HYUNDAI Technical Service Bulletin

20-BD-017H

Santa Fe (TMa)

FUEL FILLER DOOR HOUSING REPAIR

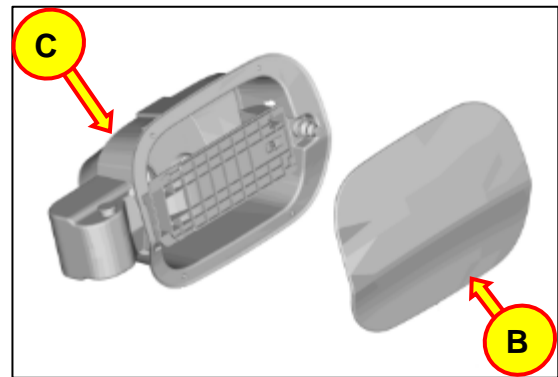
Description: This bulletin outlines the repair procedure to replace the fuel filler door housing on certain Santa Fe (TMa) vehicles if the fuel filler door is not flush to the body while closed, cannot fully close, or exhibits sagging/misalignment conditions while open. The existing fuel filler door panel will be reused.

1. Refer to the shop manual to remove the fuel filler door assembly (A).

2. Remove the existing fuel filler door panel (B) from the fuel filler door housing (C).

Reuse the existing fuel filler door panel (B), and install on the replacement housing.
